# **Deadline 5 Submission on Behalf of the Neighbours and Users of Queen Elizabeth Park**

**Nick Jarman**

Interested Party reference no: **20022545**

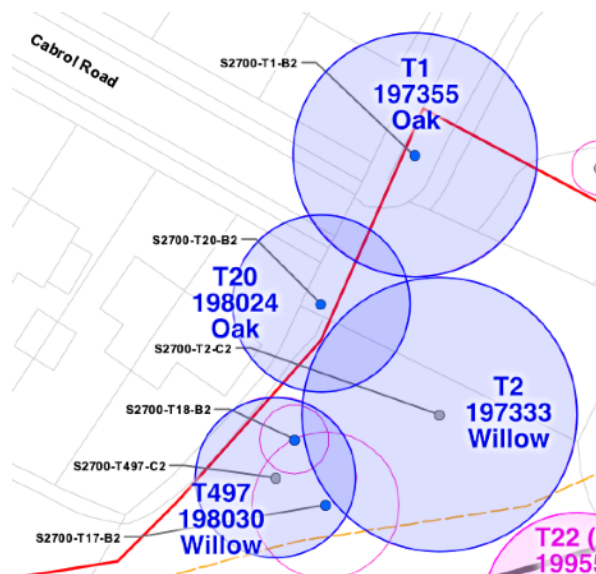
The image below shows the Notable Tree in the proposed Cabrol Road construction compound. It is listed in the Woodland Trust's ATI as number 198027.

### **Beech S2700-T270 (Notable)**

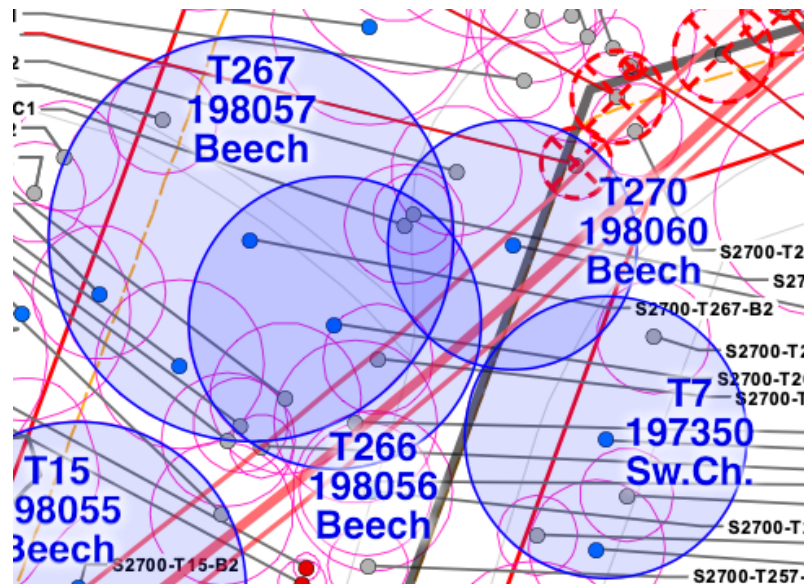
This tree is critically endangered by the trench, which passes so close to the trunk that it seems impossible that the tree can be retained. We calculate that the trench passes 0.8 metres from the centre of the trunk and severs 44% of its root area. We are deeply concerned that this tree will be removed to facilitate trenching. Whilst we understand that Esso do not currently plan to remove this tree, the DCO gives them the power to do this if needed. We would be interested to hear Esso's comments on this.

### **Sweet chestnut S2700-T9**

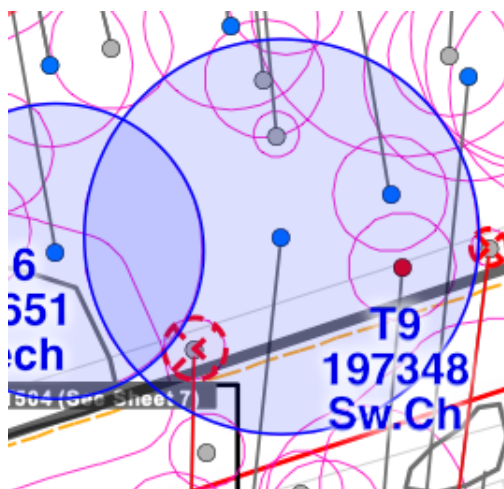
This tree has 20% of its root area severed, with the trench 6 metres away from the centre of its trunk.

### **Oaks S2700-T468 and S2700-T473 and beeches S2700-T475 and S2700-T480**

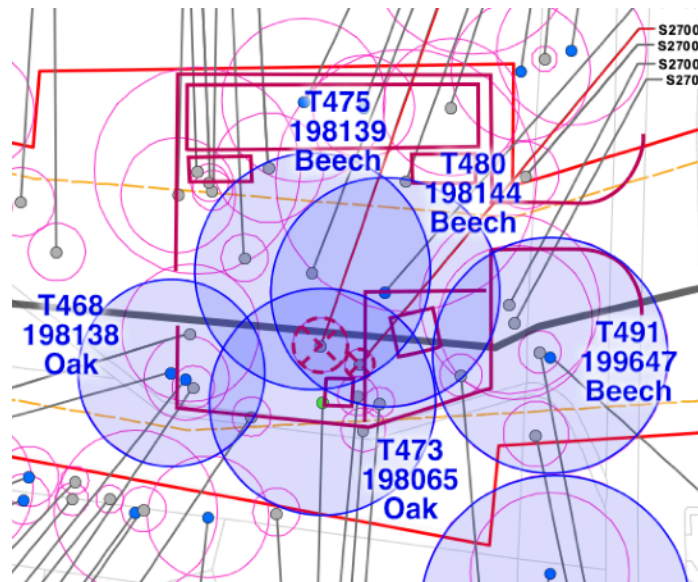
These trees are all affected by the trench, having between 16% and 27% of their root areas severed. These are all Notable Trees. The added complication for this group of trees is that they are in the auger boring compound and will be exposed to other threats described in subsequent sections.

### **Veteran beech S2700-T5 and sweet chestnut S2700-T4 (Notable)**

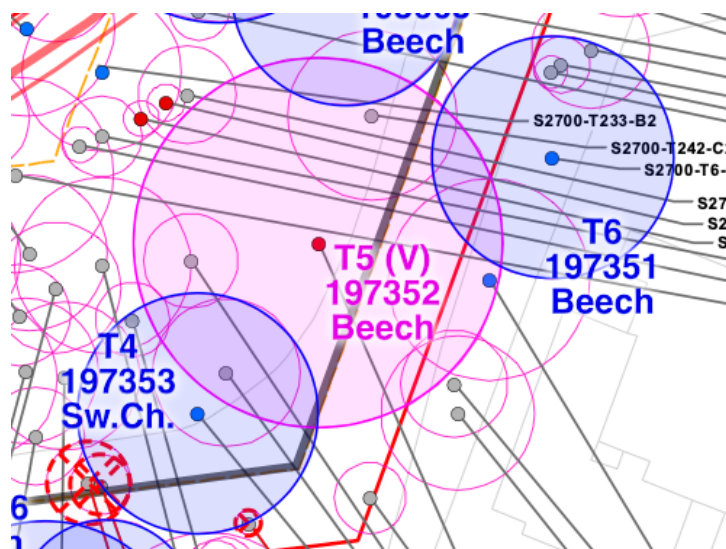
The Veteran beech has 32% of its root area severed, with the trench 4.2 metres from its trunk whilst sweet chestnut S2700-T4 (Notable) has 20% severed. Beech S2700-T6 (Notable) is just outside the trench area but at risk depending on the actual extent of its roots and the final path of the pipeline.

**Scots Pine S2700-T167 (Notable)**

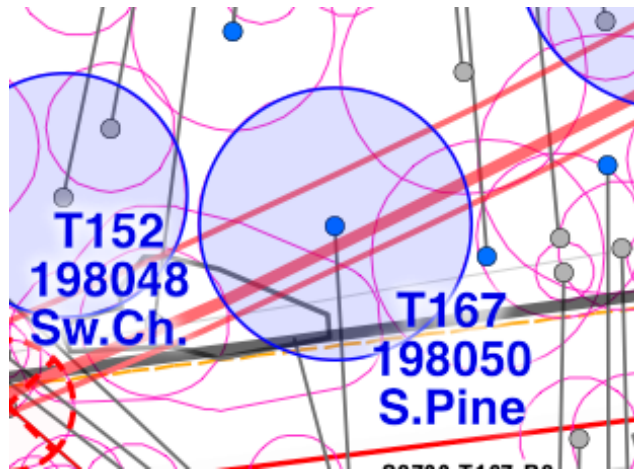
This tree has 7% of its root area severed and will be further stressed by stringing activities (see section 2.4):

**Oak S2700-T35 (Notable)**

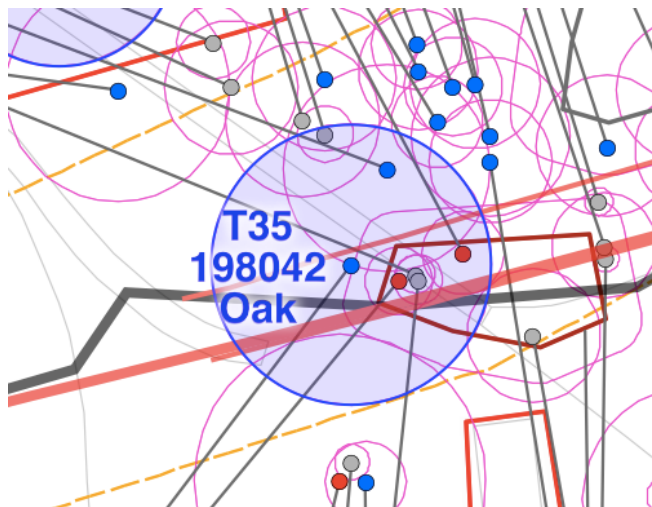
This tree is in grave danger because of the proximity of the trench to its trunk. 34% of its root area will be severed as the trench passes 2.5 metres from the centre of its trunk.

## Blocker 2

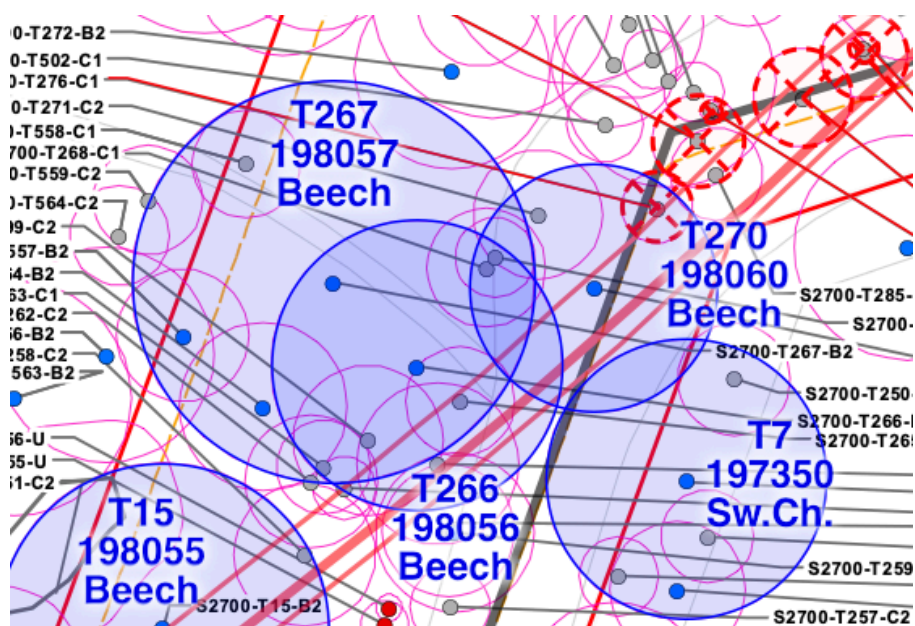
Beeches S2700-T267 and S2700-T270 (both Notable) span the Order Limits, with beech S2700-T266 (Notable) and sweet chestnut S2700-T7 (Notable) contributing additional cover.

### **Blocker 3**

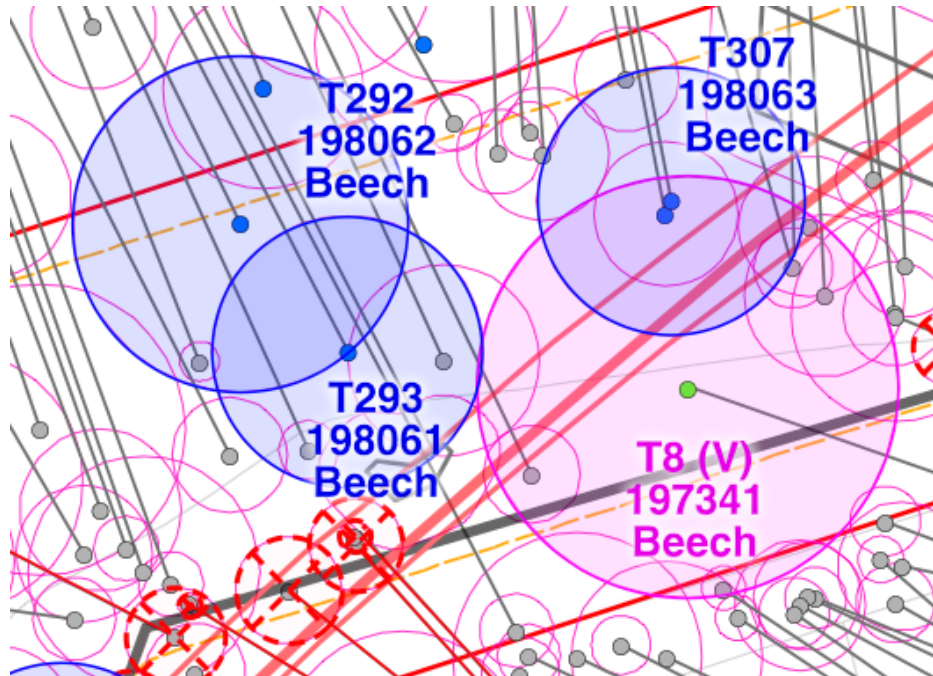
The Fairy Tree (T42/S2700-T8, Veteran) is in a group which also spans the Order Limits, with the help of beeches S2700-T293 and S2700-T292 (both Notable). Also in this group of trees is beech S2700-T307, which although it does not reach the edge of the Order Limits, does cover the Limits of Deviation.

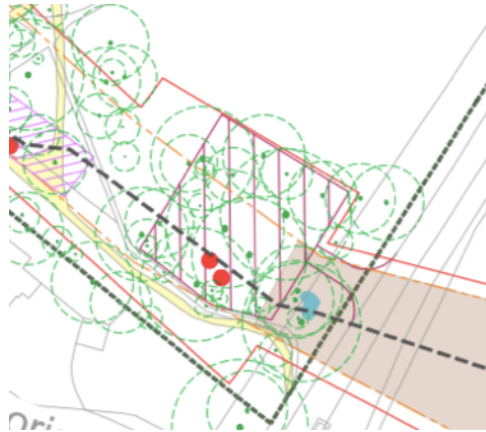
Previous drawings have shown the reception pit being located within the compound, however the 'pond' is outside the compound, as shown in the diagram below (from the QEP SSP):

The QEP Site Specific Plan states that the reception pit will be 6 x 5 metres in size and 3 metres deep. Previously the Detailed Trenchless and Targeted Open Cut Assessment<sup>6</sup>, section 1.23, gave the dimensions as 3m x 3m x 6m (deep). No reason is given for the change in size.

### 2.3.2. Completely Covered by Root Protection Areas

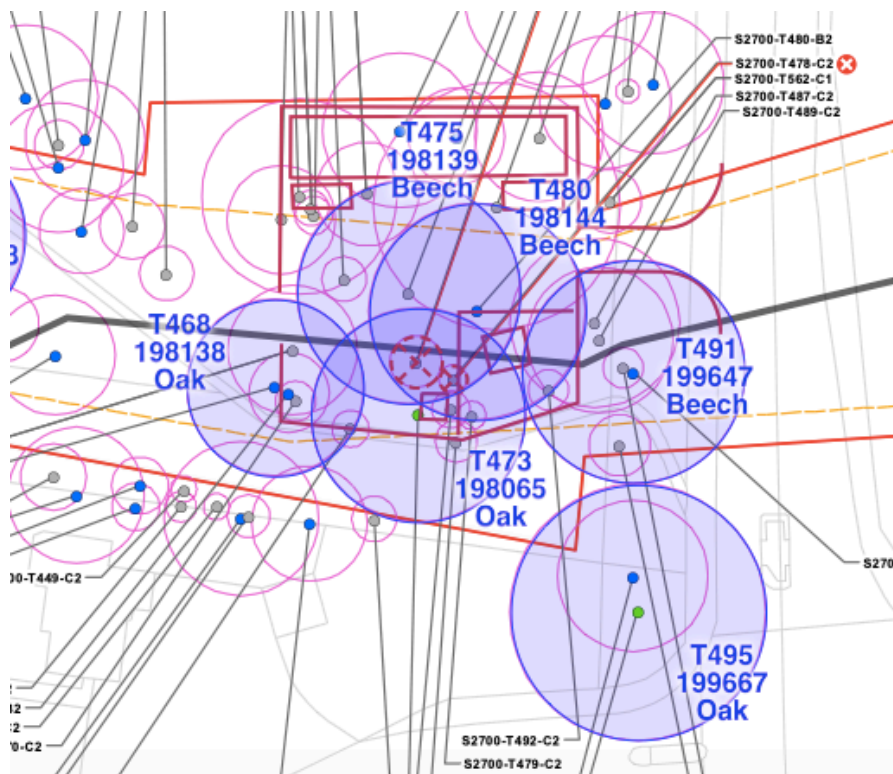
Wherever the pit is located within the compound, excavating it will cause the loss of many of the trees due to the destruction of their root areas. There may be no intention to remove the trees before work starts, but the amount of roots damaged by the work will be significant.

This is one of the densest areas of Notable Trees in the park, containing S2700-T475, S2700-T480, S2700-T468, S2700-T473 and S2700-T491 as shown above.

### 2.5.2. HDD Reception Compound

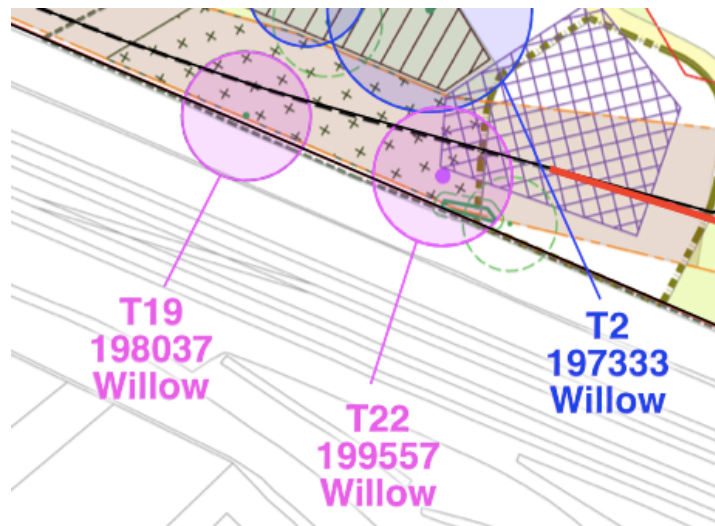
The HDD bore for TC018 passes through the root protection areas of two Veteran Trees. These are both willows, S2700-T19 and S2700-T22 (previously identified by Esso as T41).

Both trees are at risk due to the HDD bore rising up through their roots to the reception pit. T22 is most at risk, whilst the potential damage to T19 is unclear without knowing how deep the bore will be as it passes beneath the tree. A sectional diagram showing the bore and trees in this section is needed from Esso.

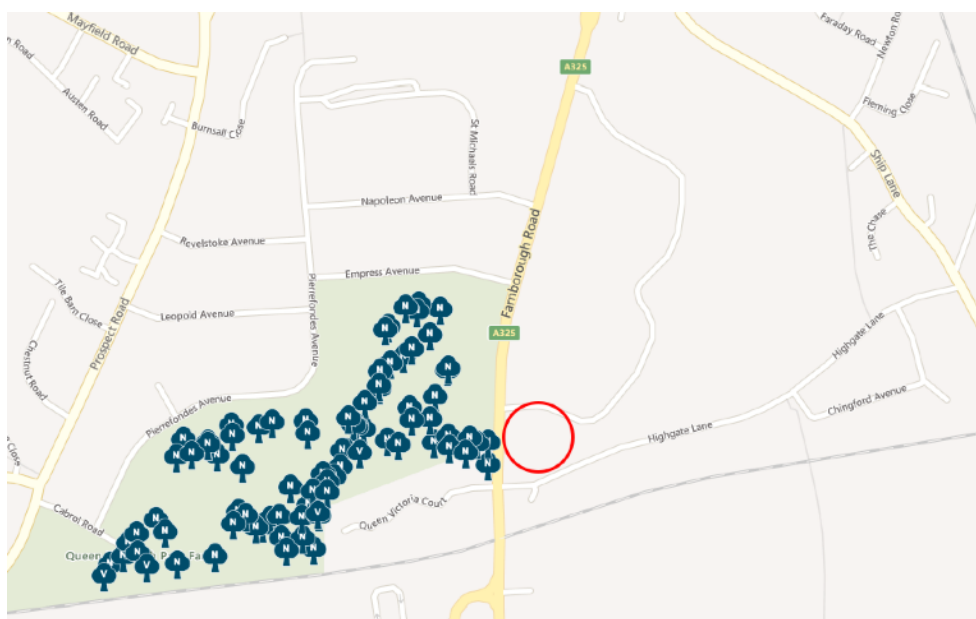
Esso's illustration 2 for point 1.3 shows that a strip of trees 5 metres wide would have to be cleared at the end of the stringing area. This is not consistent with the reassurances which Esso have given about their stringing activities in Queen Elizabeth Park, where they say they can retain all trees in the stringing area. It would be useful if Esso could explain the discrepancies between these two statements.

Of course using the 2 pull method above would avoid the boundary trees in Farnborough Hill completely.

## 5.2.14. Wildlife Pond

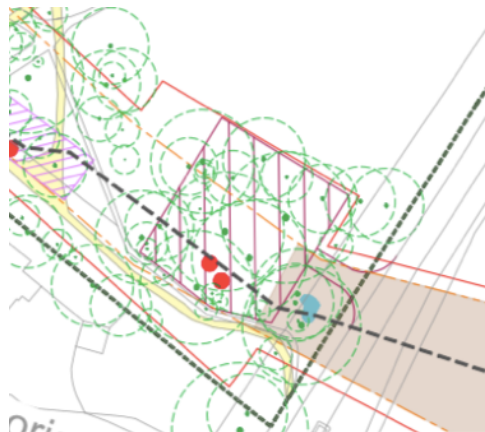
As stated in the previous section, the water body is outside the proposed compound. This is shown in Appendix B of the QEP SSP:

We would like to clarify that there is no wildlife pond on the eastern side of the park. There is a dip in the ground which collects water during heavy rain, but it is not a wildlife pond.
